PLUMBING AND FIRE SPRINKLER HEAD
PLAN KEYNOTES

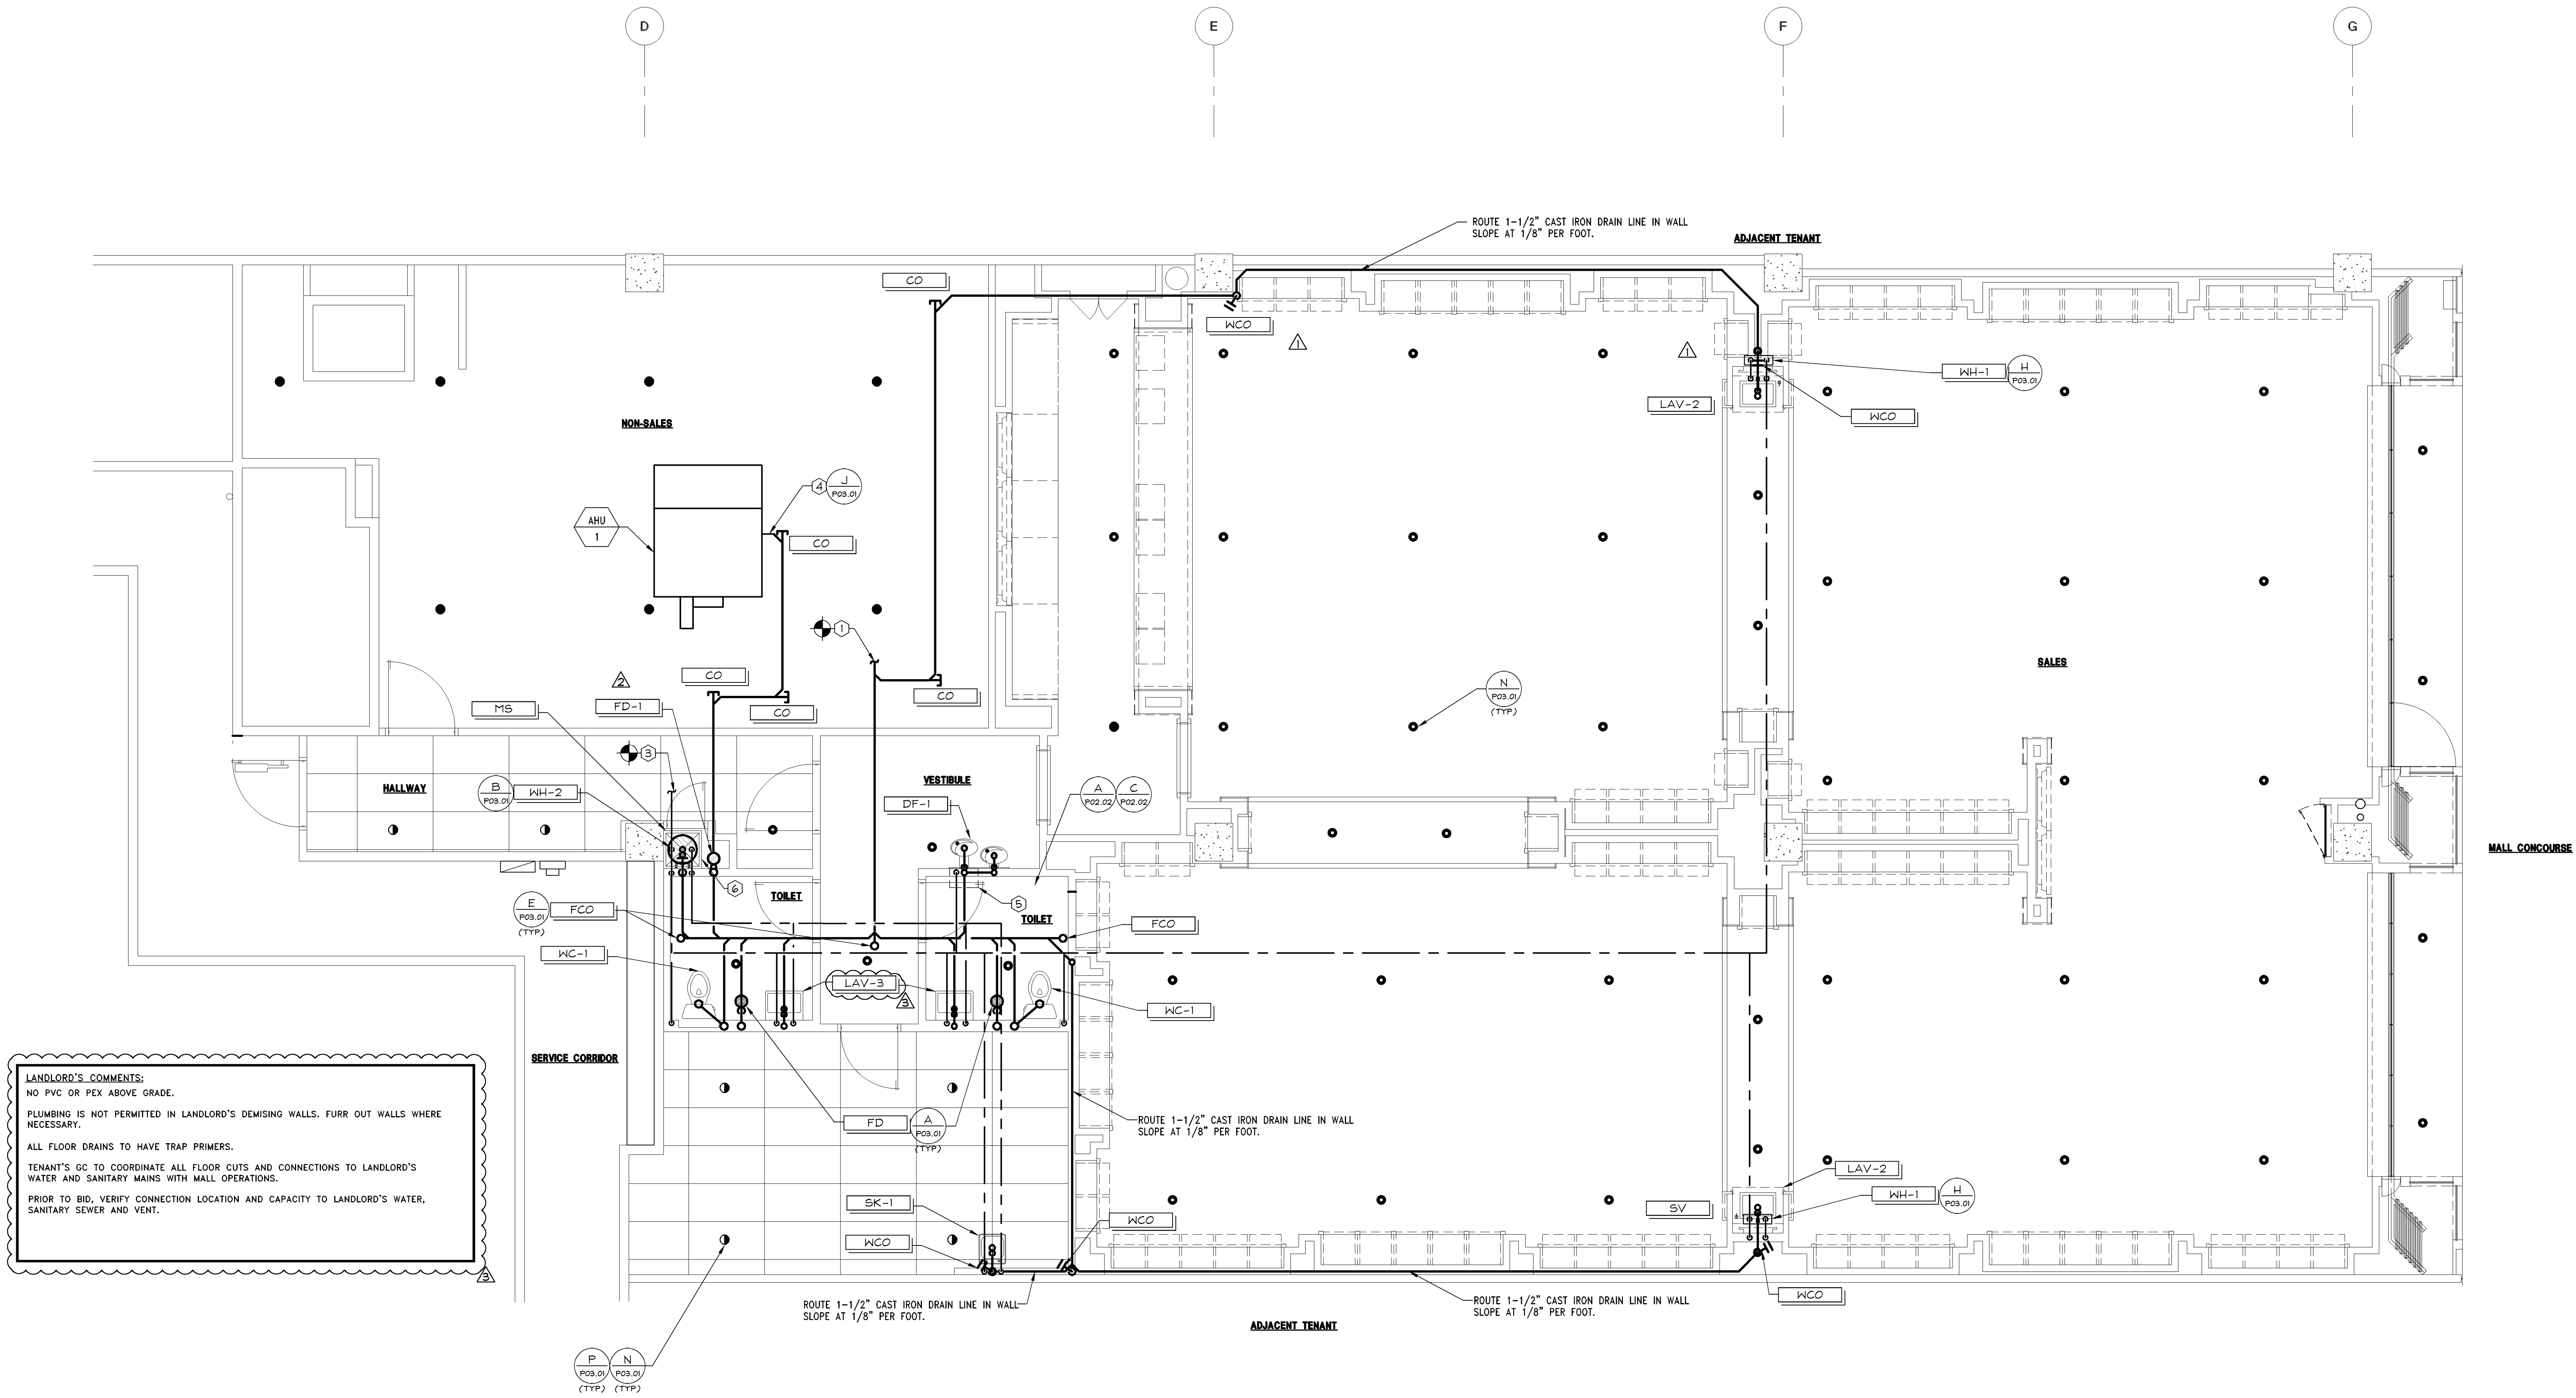
GC TO PROVIDE WRITTEN REPORT TO LSD&C PM ON CONDITION OF EXISTING SEWER TIE-IN REGARDING SLOPE AND FLOW.
• SCOPE WITH CAMERA PRIOR TO CONNECTION
• DO NOT CONNECT WITHOUT LSD&C PM AUTHORIZATION IF SPECS NOT MET

LANDLORD'S COMMENTS:
NO PVC OR PEX ABOVE GRADE.
PLUMBING IS NOT PERMITTED IN LANDLORD'S DEMISING WALLS. FURR OUT WALLS WHERE NECESSARY.
ALL FLOOR DRAINS TO HAVE TRAP PRIMERS.
TENANT'S GC TO COORDINATE ALL FLOOR CUTS AND CONNECTIONS TO LANDLORD'S WATER AND SANITARY MAINS WITH MALL OPERATIONS.
PRIOR TO BID, VERIFY CONNECTION LOCATION AND CAPACITY TO LANDLORD'S WATER, SANITARY SEWER AND VENT.
